Frost Seawall

CHAPTER 343, HRS  
Environmental Assessment (EA)/Determination  
Finding of No Significant Impact

**APPLICATION FOR SHORELINE SETBACK VARIANCE  
AND  
FINAL ENVIRONMENTAL ASSESSMENT**

**Reconstruction of Seawall**

Typical CRM  
Modified Seawall Section  
Source: TNWRE, 1997  
Figure 7

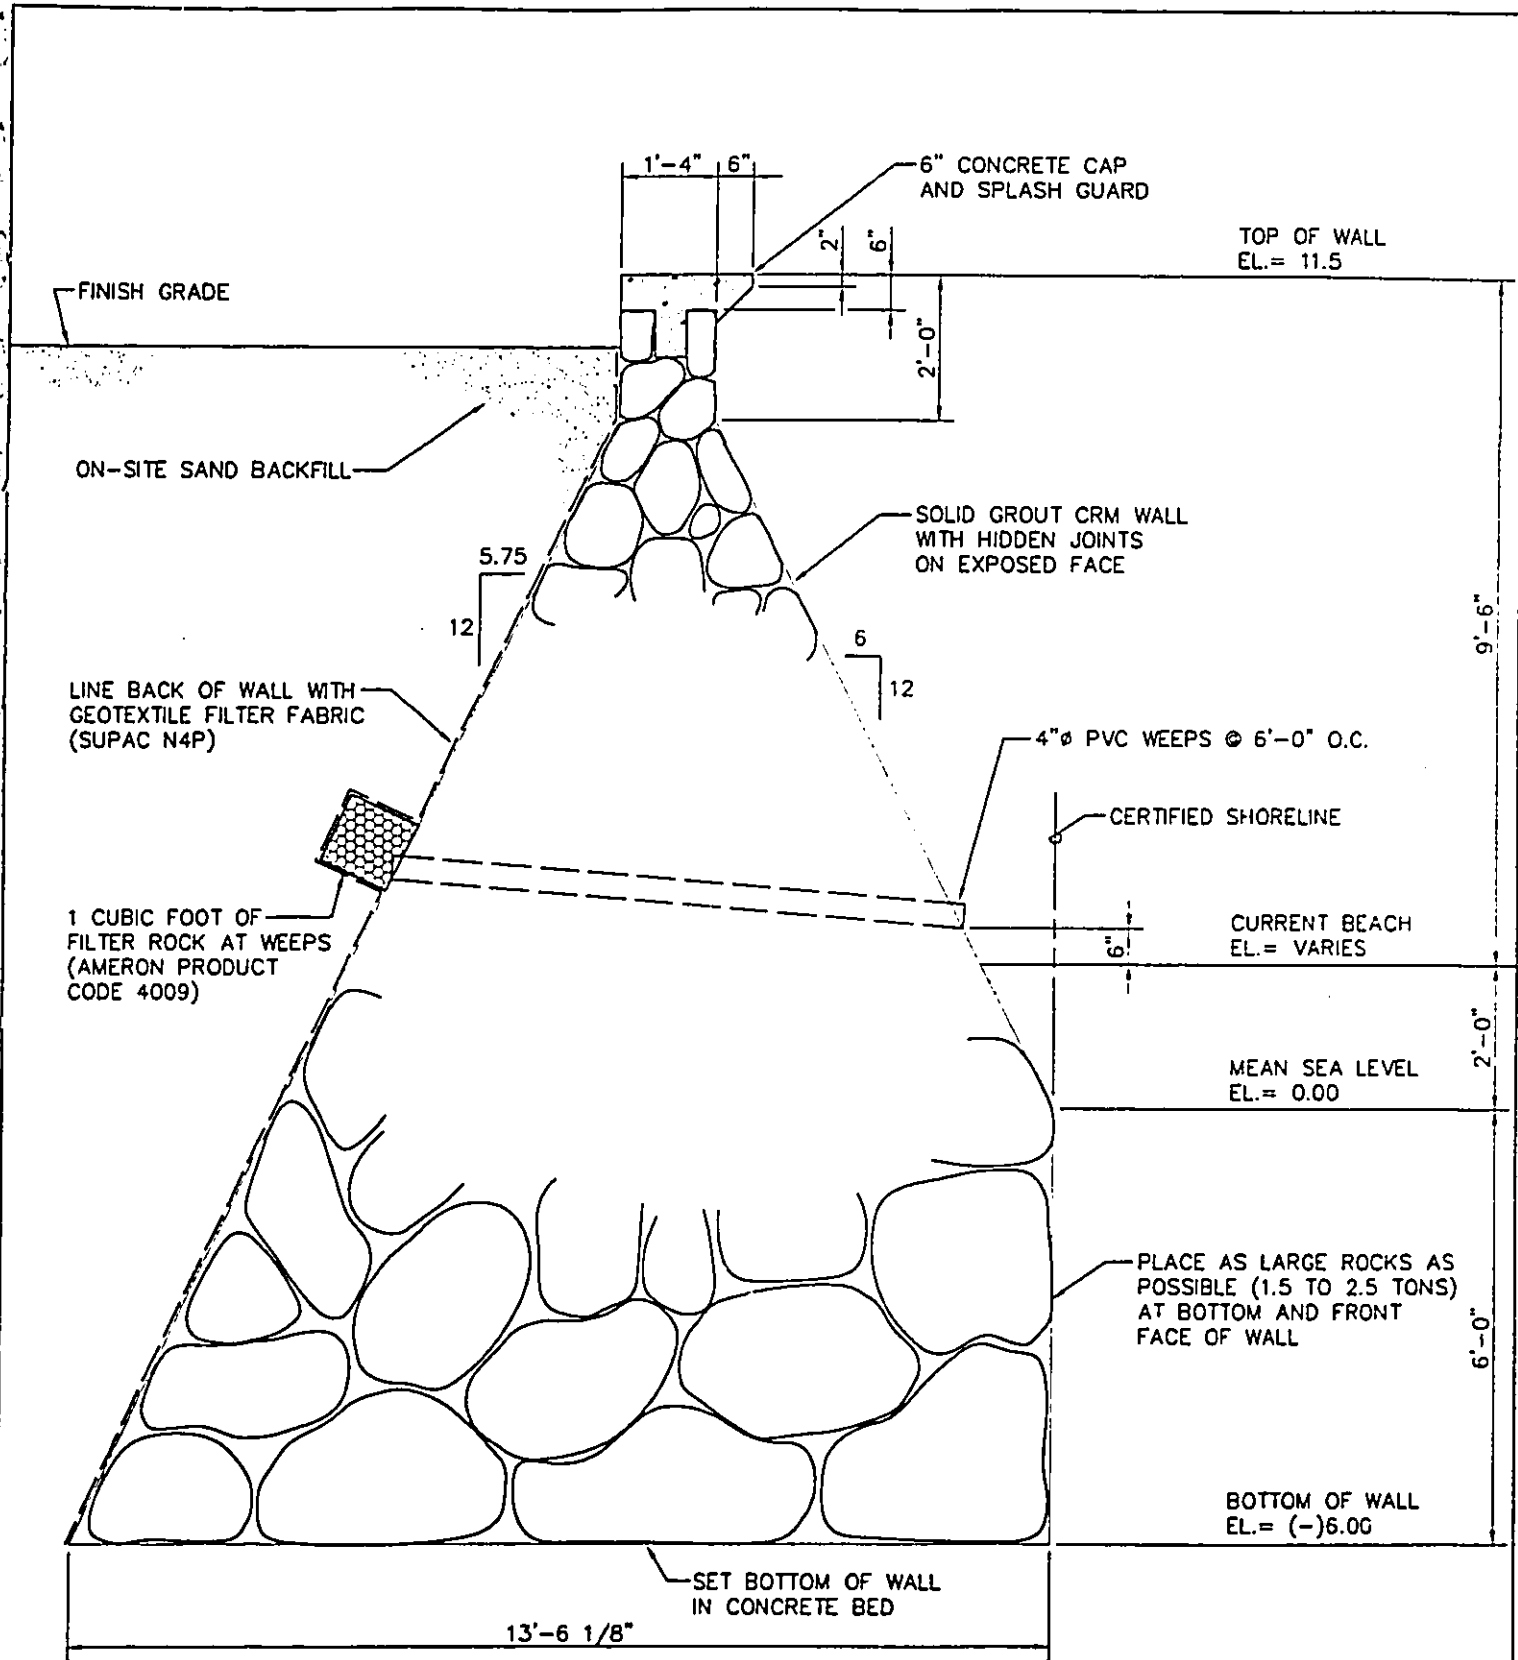
Figure 7 in the DEAs illustrate the design of the proposed seawall structures. The tops of the proposed seawalls are only 1' 10" wide. This hardly seems adequate to allow "safe" lateral access to the shoreline especially during times of high surf events. The proposed seawalls should be designed to allow shoreline access without presenting a safety hazard to the public.

2. **Lateral Shoreline Access.** The four seawalls are aligned together and match the adjoining properties on either side. At this location, there are 16 properties in a row that are all protected by vertical seawalls. The beach along this entire section of the Mokuleia coast could be considered very narrow. Lateral passage along this shoreline in front of the seawalls will be improved by the proposed action, which will remove loose rock debris and deteriorated wall sections, and replace these with an engineered modified vertical seawall structure. With the lower sloped portion consisting of large rock material, there will be a return of a slightly wider beach for lateral passage. At the three lots to the west where modified vertical seawalls were recently built with the hybrid wall design, there has been a recent return of a narrow strip of beach sand along a section where there was no beach sand for lateral passage in the recent past.

Figure 2

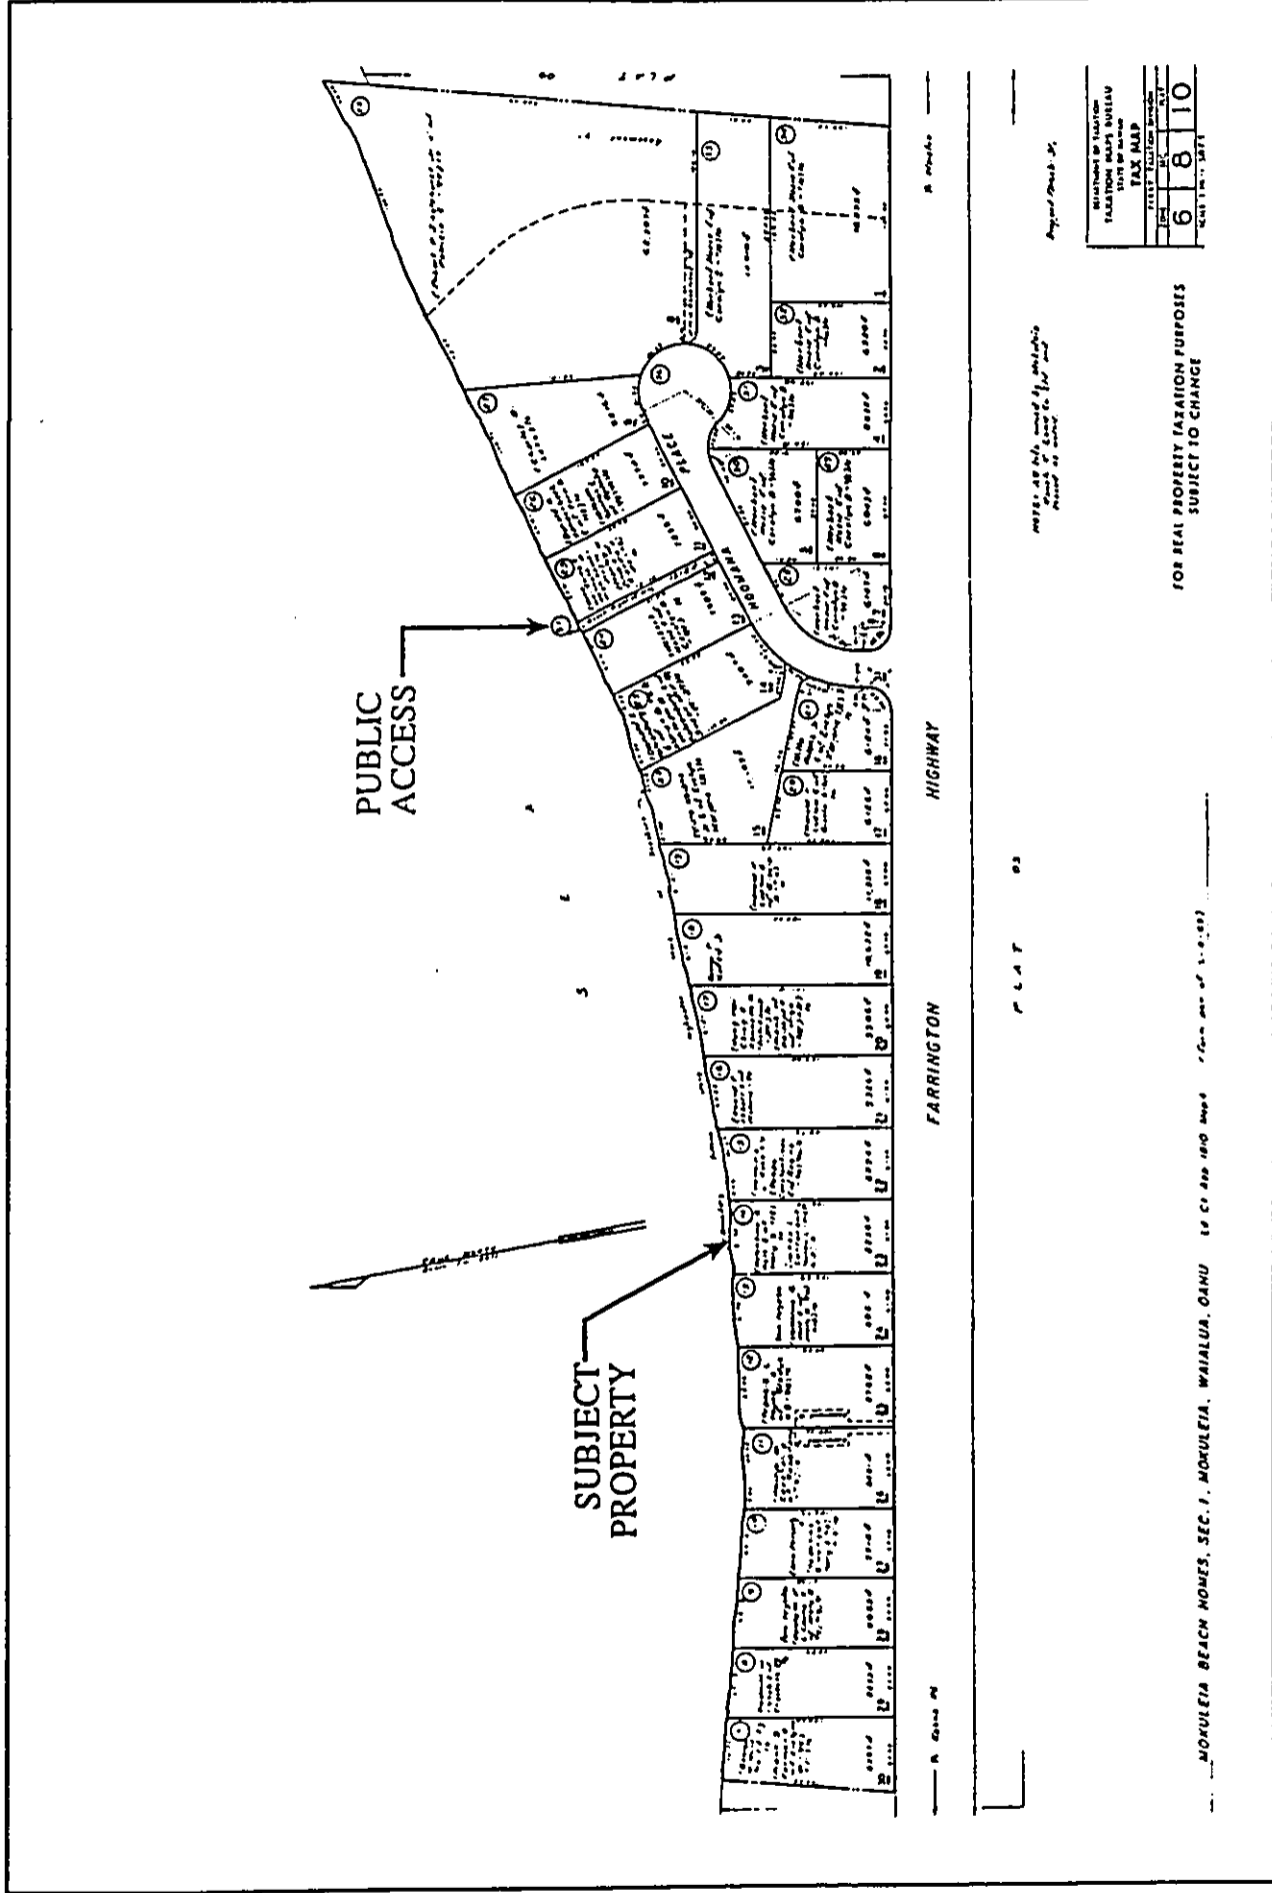
3. Site maps that clearly show the current certified shoreline, previous certified shorelines, the private property line and the location of the proposed structure. Any nearby public access right-of-way should also be depicted.

1) **Public Access.** The closest public access right-of-way is depicted in the TMK map shown in Figure 2. An access easement is found approximately 500 feet to the east off Ho'omana Street.
